Eric A. Larson
Site Vice President724-682-5234
Fax: 724-643-8069June 26, 2015
L-15-188ATTN: Document Control Desk
U. S. Nuclear Regulatory Commission
Washington, DC 20555-0001**SUBJECT:**

Beaver Valley Power Station, Unit Nos. 1 and 2
Docket No. 50-334, License No. DPR-66
Docket No. 50-412, License No. NPF-73
Response to Request for Additional Information Regarding License Amendment
Request to Adopt National Fire Protection Association Standard 805
(TAC Nos. MF3301 and MF3302)

Response to March 4, 2015 Request for Additional Information

Figure 01(j)(xi)-1. HGL height with purge mode activated at 705 seconds.

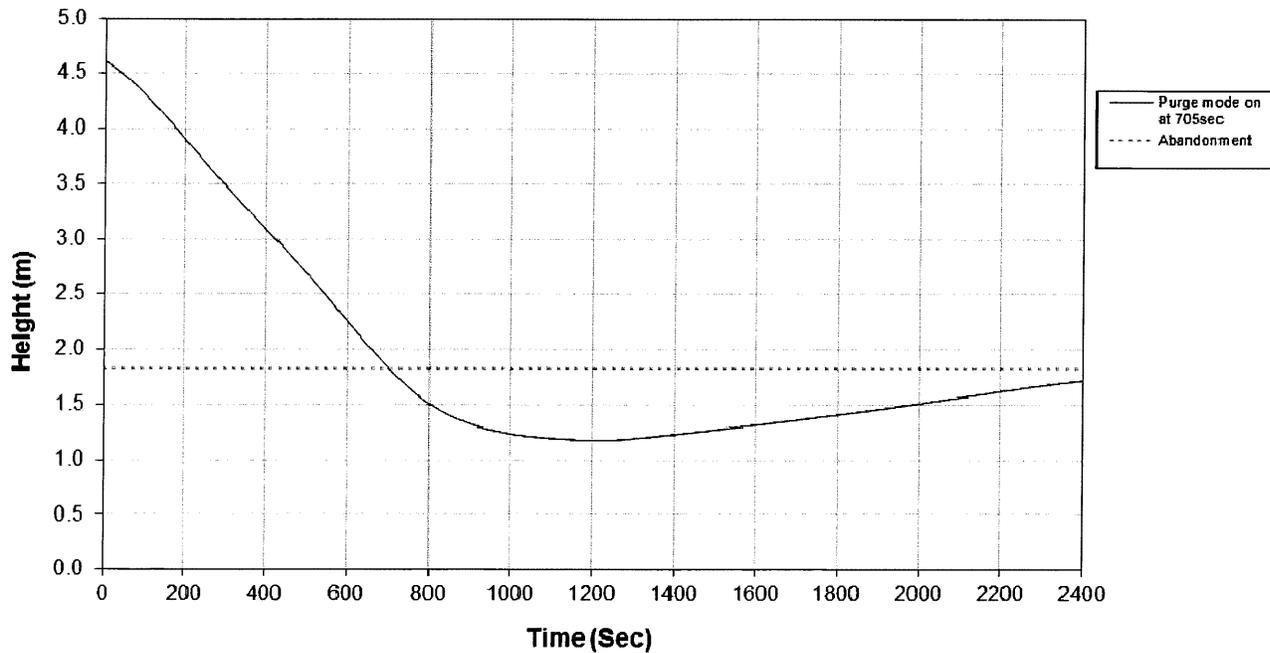
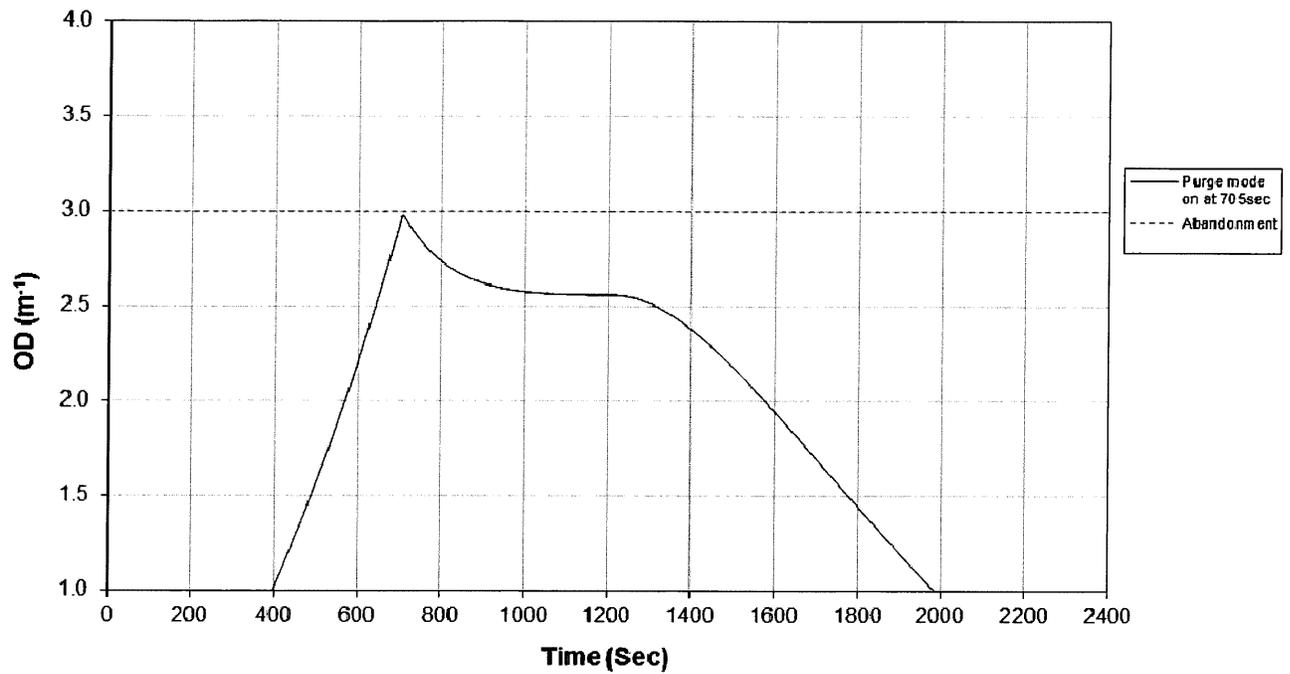
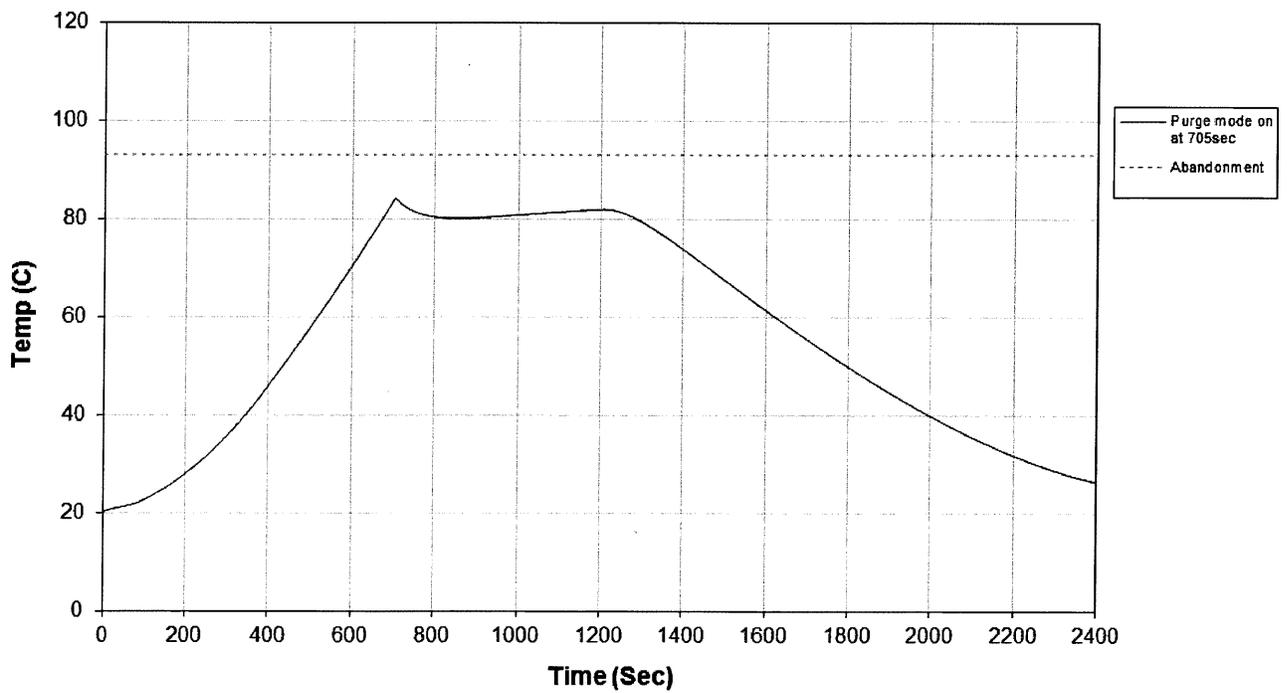
With these abandonment criteria, abandonment conditions are not achieved for the case when purge mode is activated at 705 seconds. When the activation of purge mode is delayed beyond 705 seconds (to 710 seconds), it was shown the hot gas layer height and optical density satisfy the abandonment criteria. Table 01(j)(xi) summarizes the results, and Figures 01(j)(xi)-1 through Figure 01(j)(xi)-3 present the CFAST hot gas layer profiles when purge mode is activated at 705 seconds.

Figure PRA 12-1: Simplified event tree.

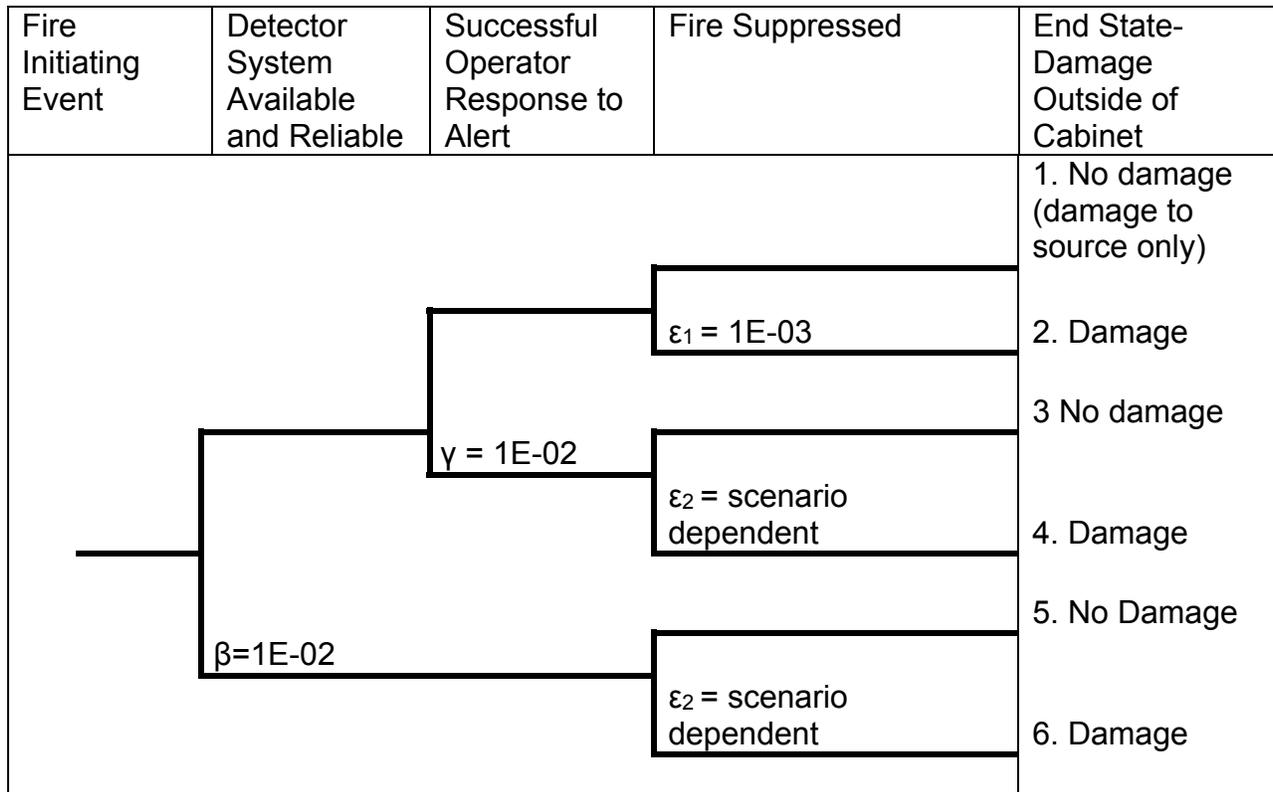
The probability of damage outside of a cabinet protected by incipient detection will depend upon the reliability and response of normal area detection and suppression as well as incipient detection. However, since the normal area detection and suppression are evaluated independently of the incipient detection, no credit has been taken for these systems in this evaluation (that is, the probability of ϵ_2 is set to 1.0). In this case, quantification of the event tree in Figure PRA 12-1 above results in the probability of failing to detect and suppress the fire prior to damage outside of the cabinet equal to 2.1E-02, based solely on incipient detection (see Table PRA 12-1 below).
